Re: Revenue Producing T-Hangar (REBID)  
Sigurd Anderson Field  
Webster, South Dakota  
AIP # 3-46-0059-011-2021  
A-7148

**ADDENDUM NUMBER 1**

**Addendum No. 1**  
**April 16<sup>th</sup>, 2021**

Project: Webster Revenue Producing T-Hangars

A0-0

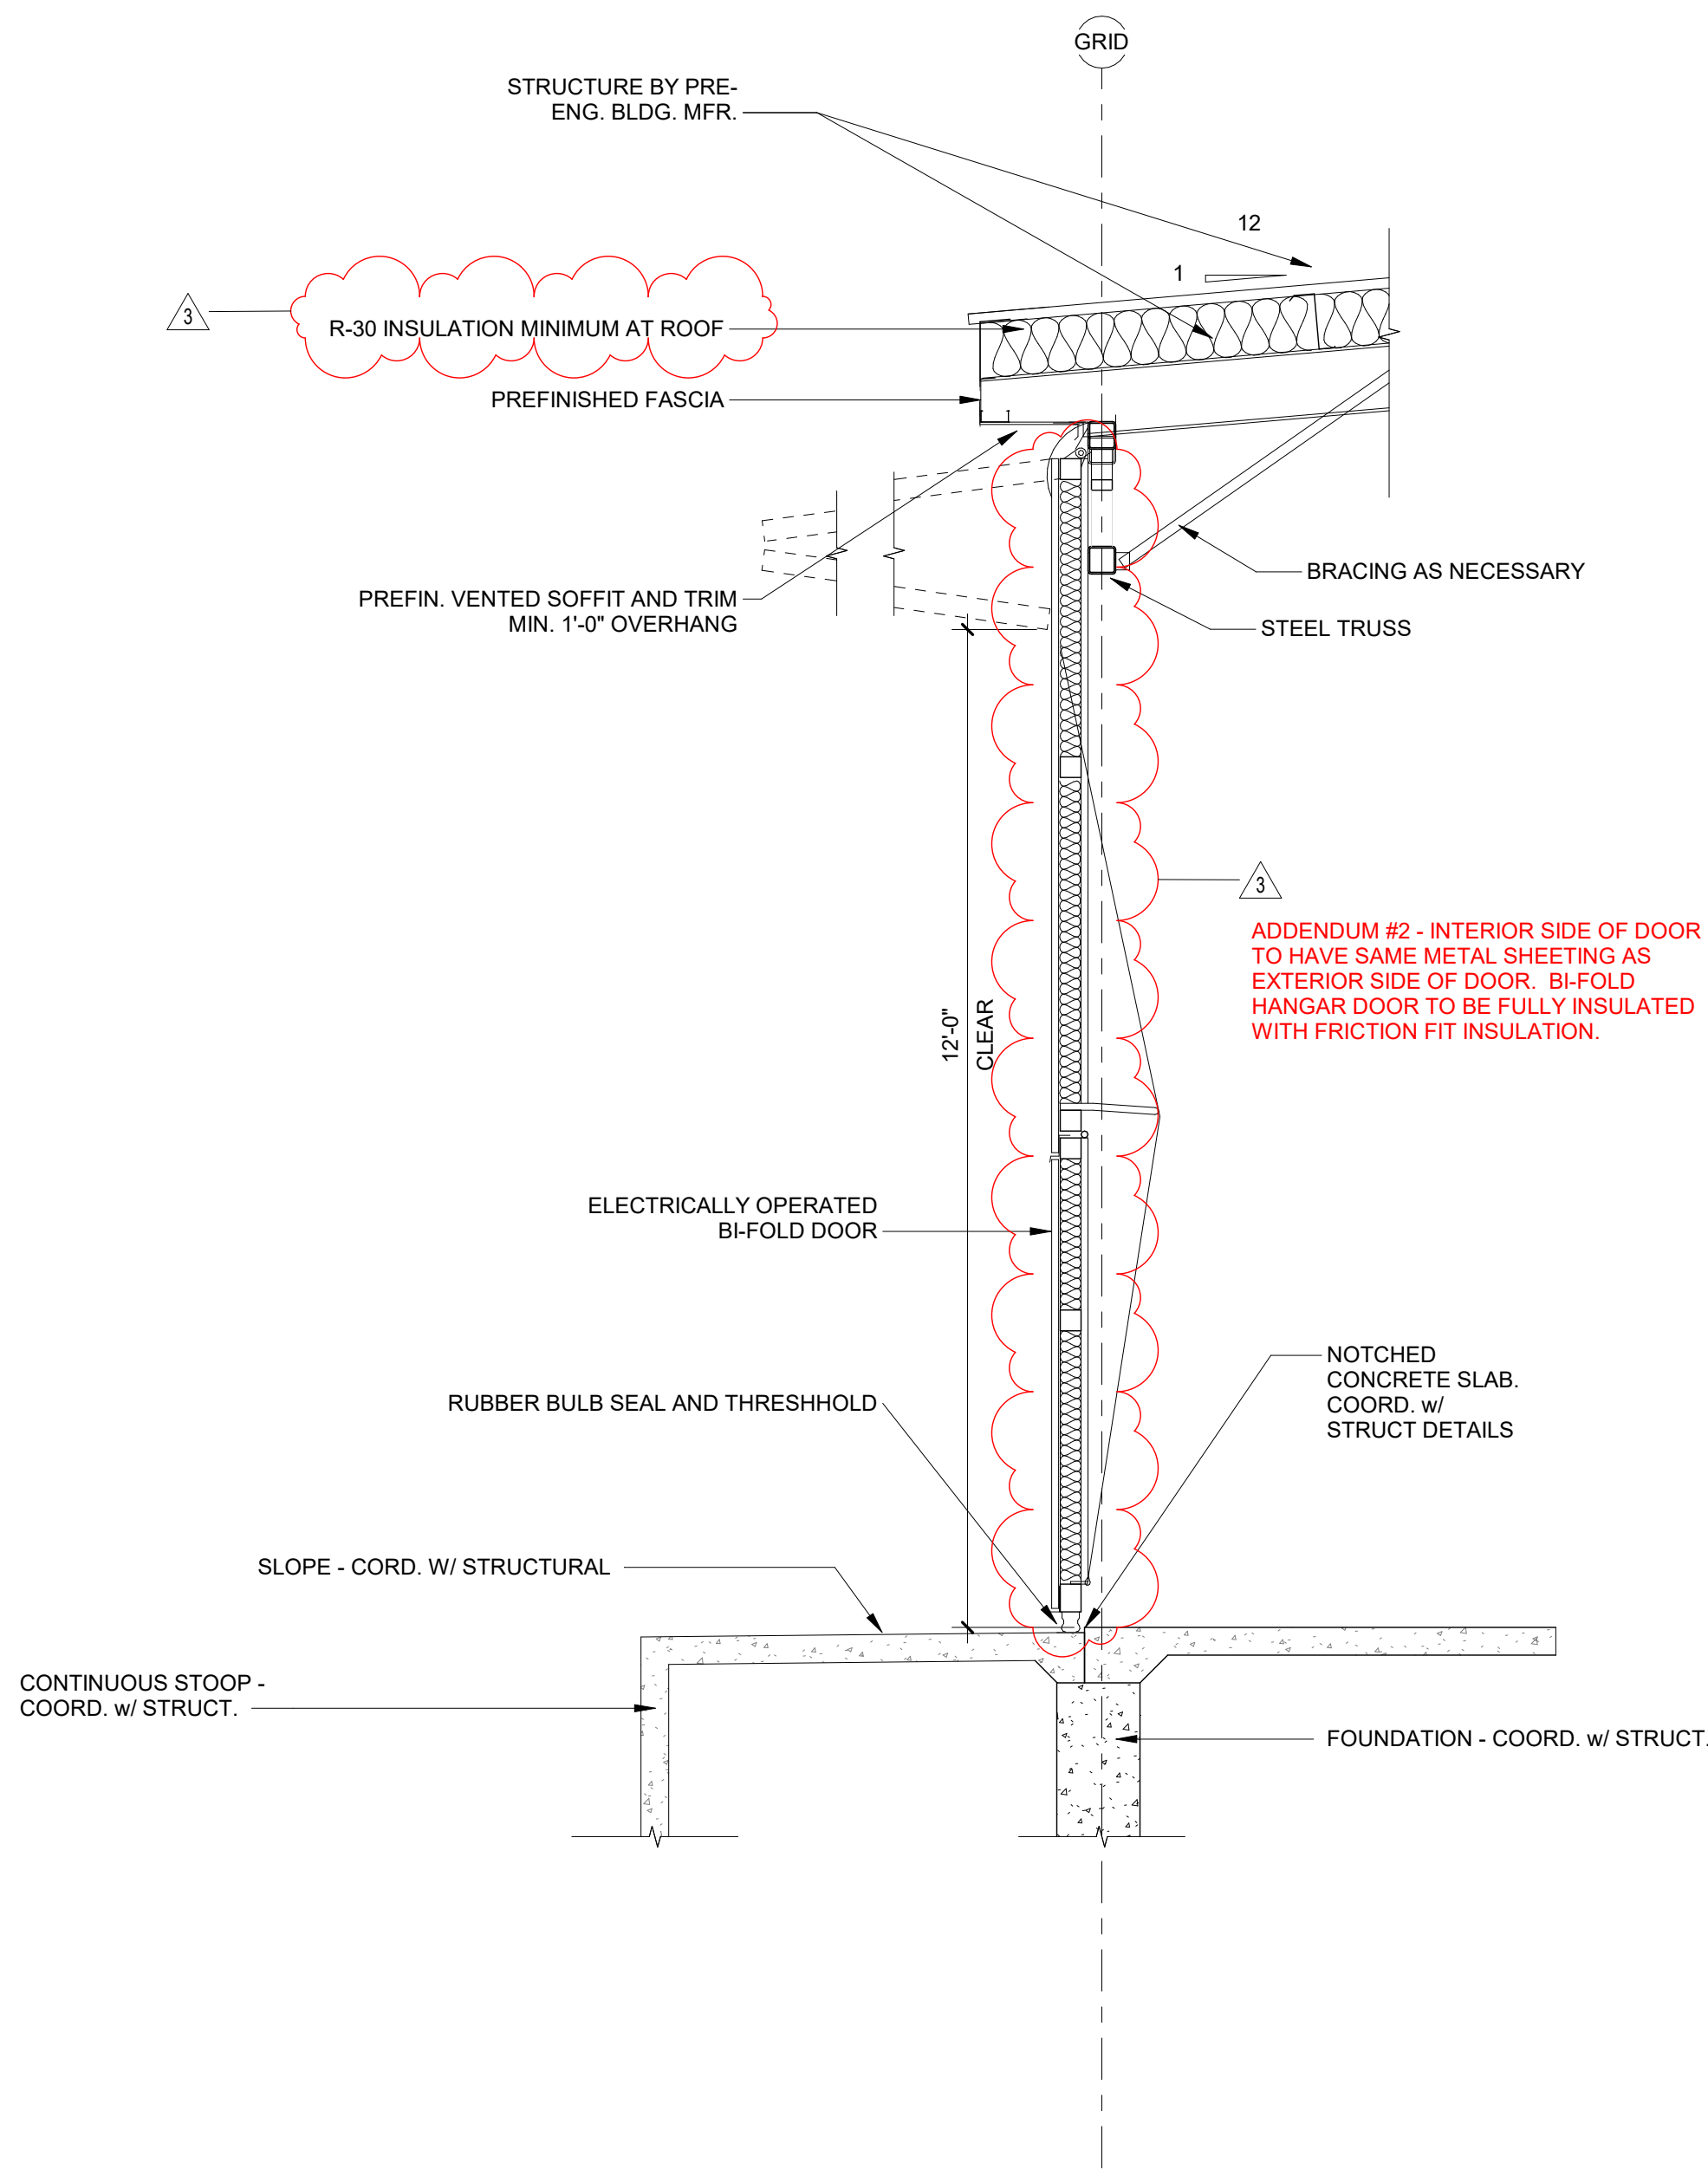
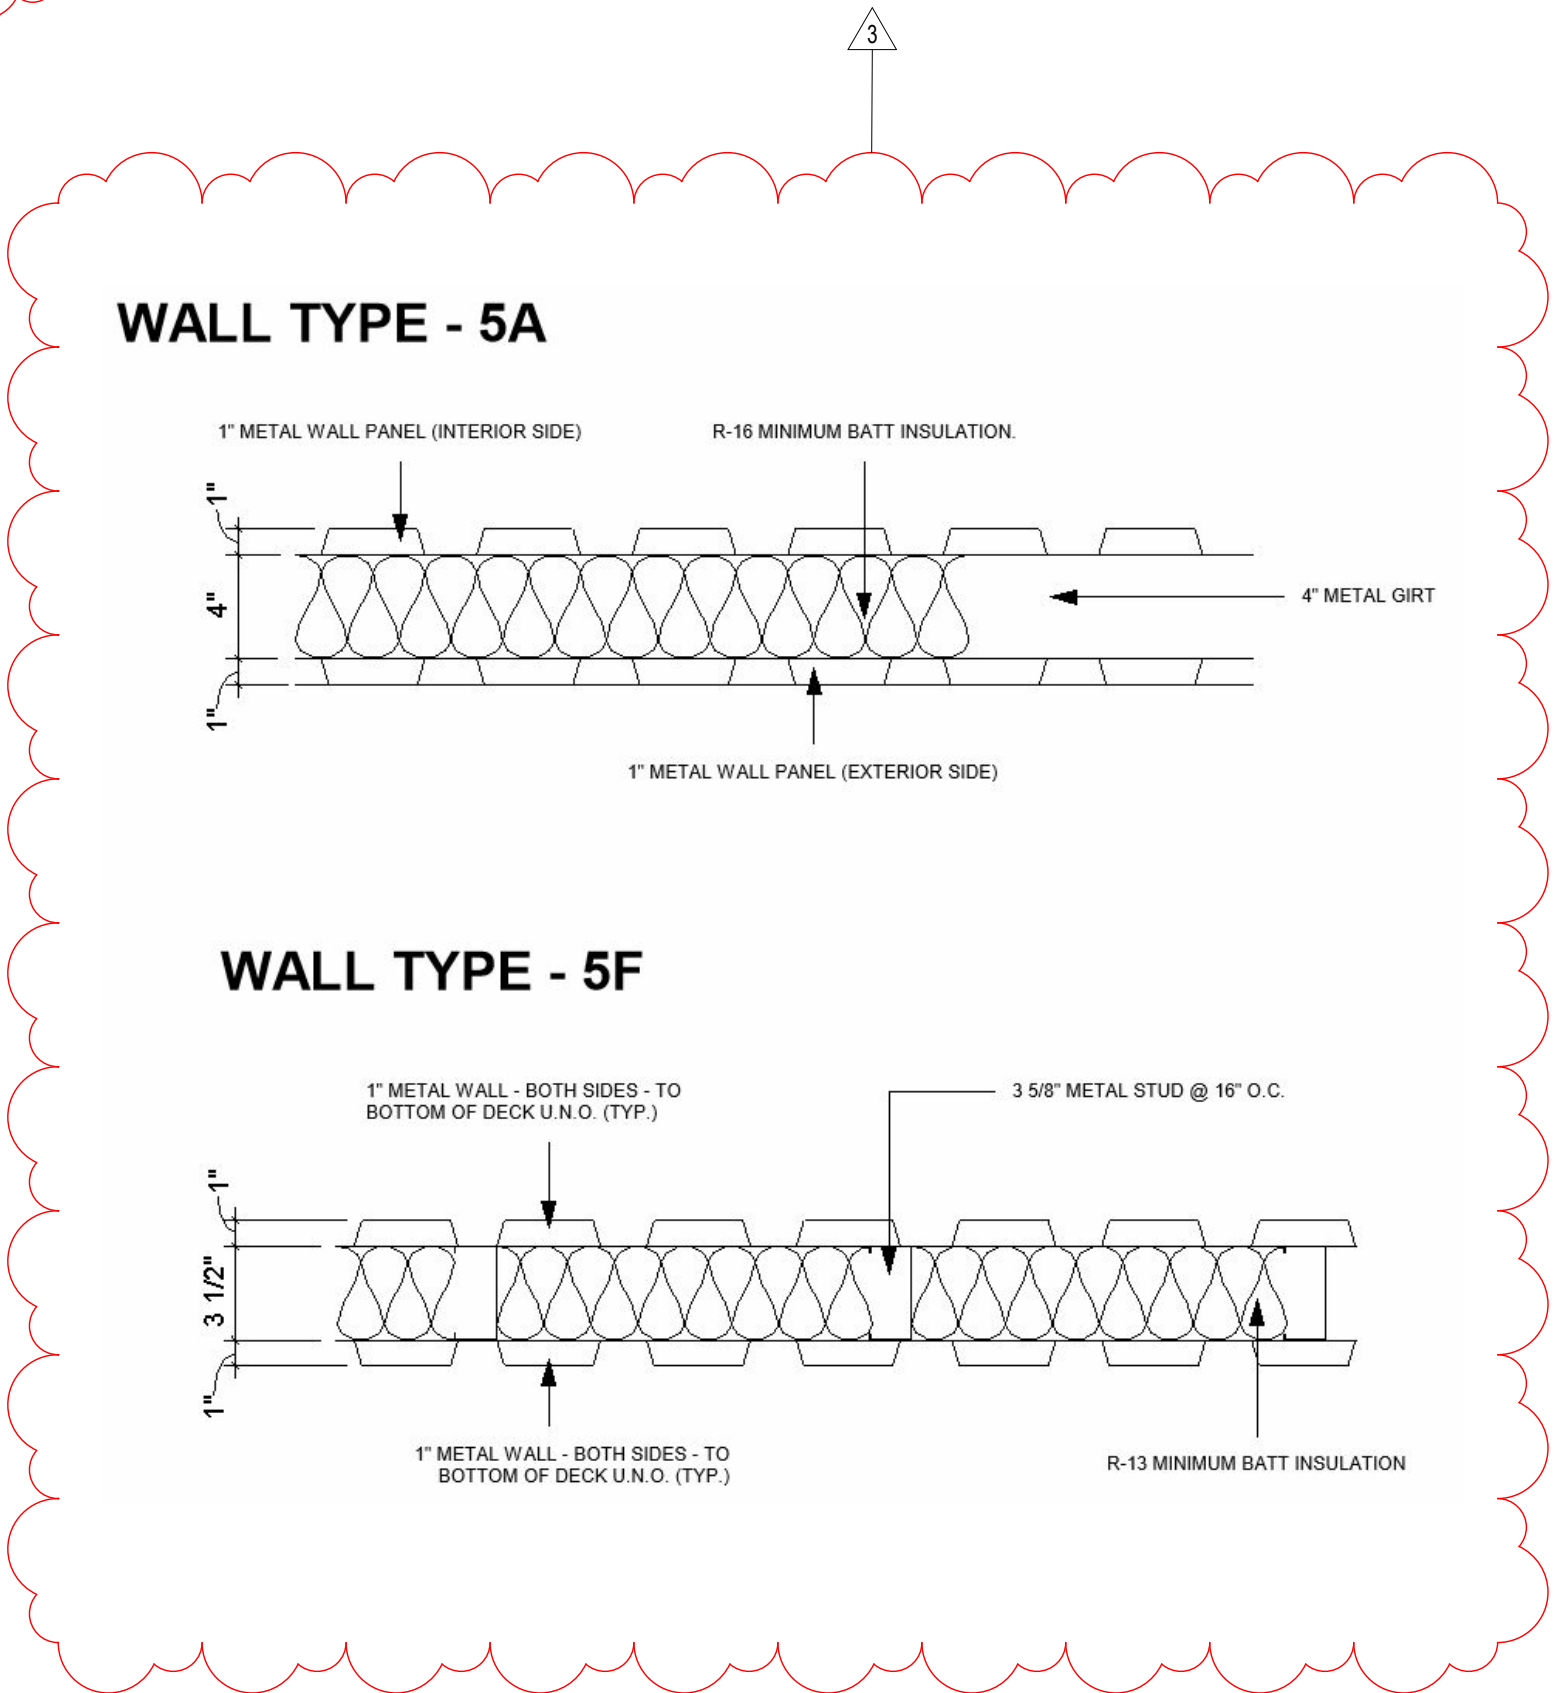
**1. DRAWING SHEET A0-0**

- a. ADDED WALL TYPE 5A Detail
  - i. Added note to Wall Type 5A that R-16 Minimum batt insulation shall be included in the wall cavity of Wall Type 5A
  - ii. See corresponding Wall Type 5A tags on the floor plan Sheet A1-4
- b. ADDED WALL TYPE 5F
  - i. Added note to Wall Type 5F that R-13 Minimum batt insulation shall be included in the wall cavity of Wall Type 5F.
  - ii. See corresponding Wall Type 5F tags on the floor plan Sheet A1-4
- c. ADDED Detail #2 – Door Type HD – (Bi-Fold Hangar Door)
- d. ADDED Detail #3 – Door Type F – Passage Door within Bi-Fold Door

1 WALL SECTION AT HANGAR DOOR  
1/2" = 1'-0"

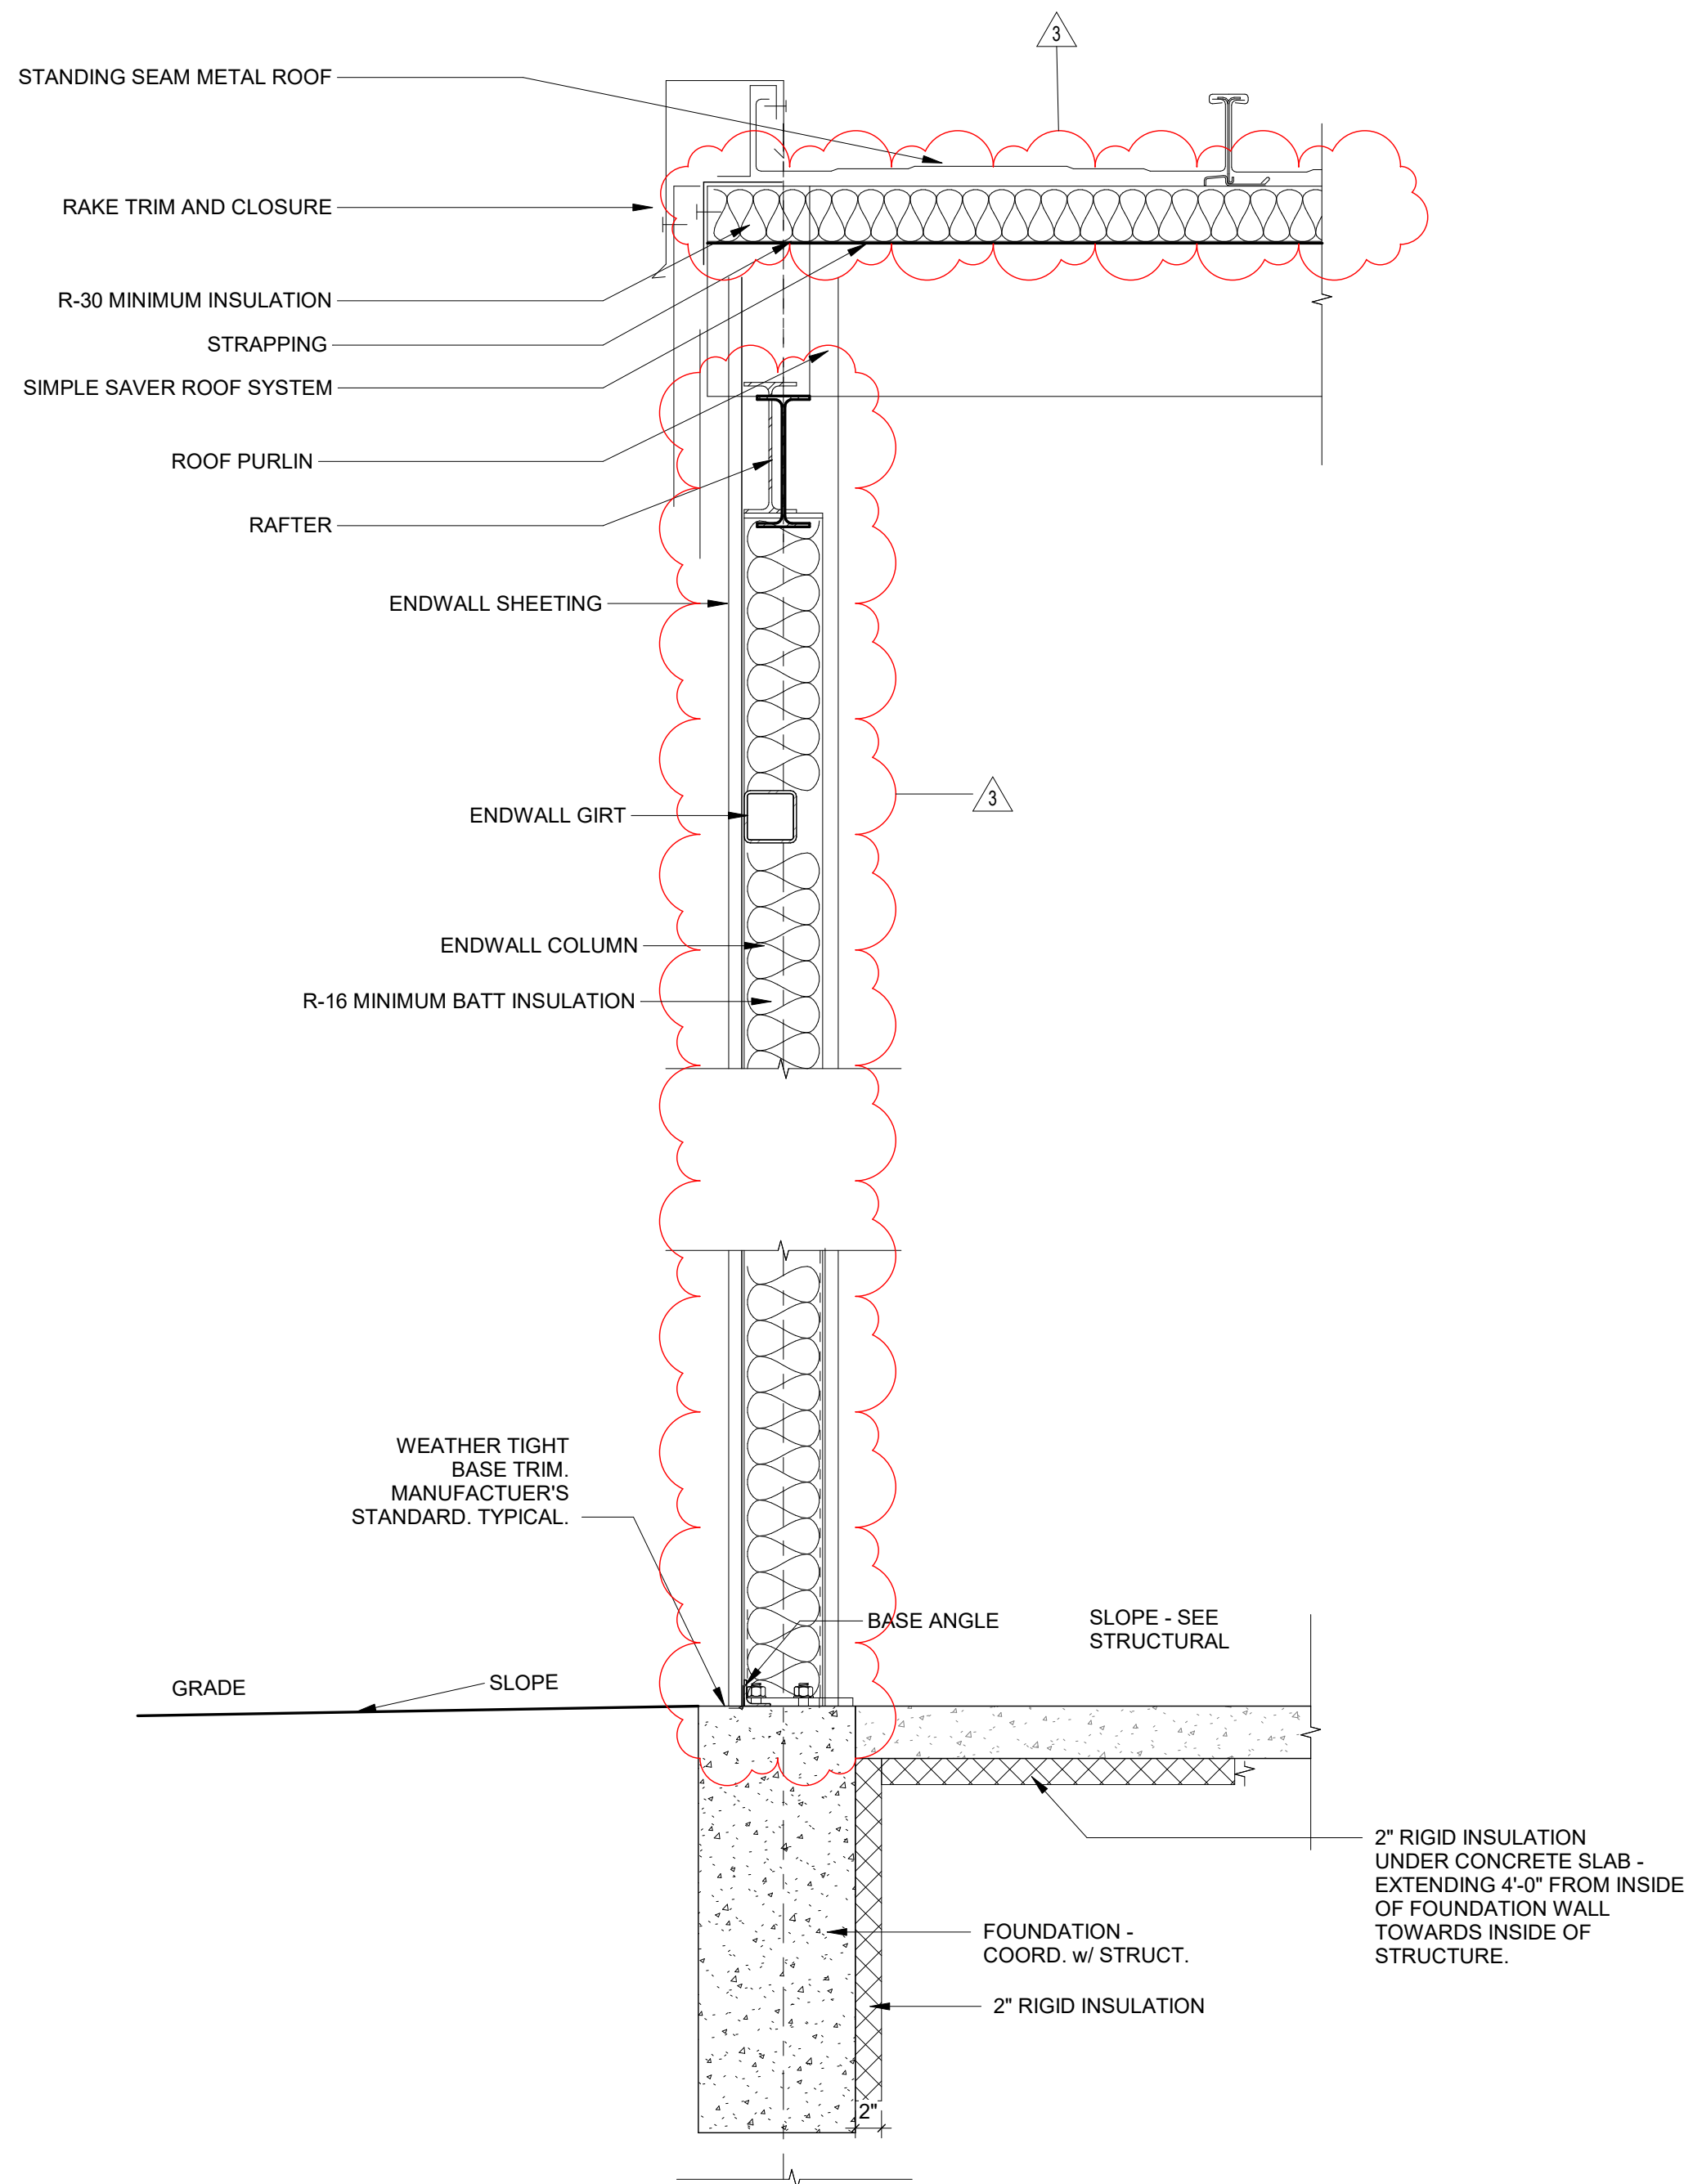
**2. DRAWING SHEET A1-5**

- a. **Detail #1** – Bi-fold hangar to do be fully insulated as per manufacturer's specifications and the interior side of the bi-fold hangar door shall be sheeted in metal wall panel and painted to match all adjacent wall panels. Metal sheeting must be installed on both top and bottom half of the bi-fold hangar door, and all trim, edging, and finishes must be provided and installed as per the bi-fold hangar door manufacturer requirements.
- b. **Detail #1** – Minimum R-30 Batt insulation at Roof
- c. **Detail #2** – Eliminate stub wall detail at foundation as shown. To be constructed as shown on structural drawings – reference sheet S-2.0 – Detail #1 Typical Foundation Section.

2 END WALL SECTION  
1" = 1'-0"

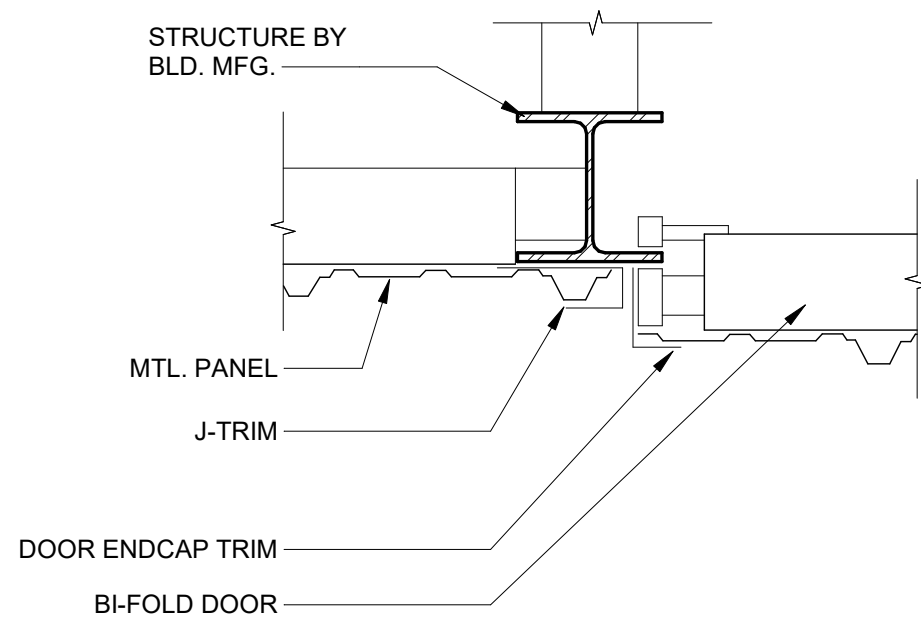
d. **Detail #2 –**

- i. Provide at minimum R-30 batt insulation at Roof, held in place w/ banding and Simple Saver system as basis of design.
- ii. Provide at minimum R-16 batt insulation friction fit in wall cavity for wall type 5A
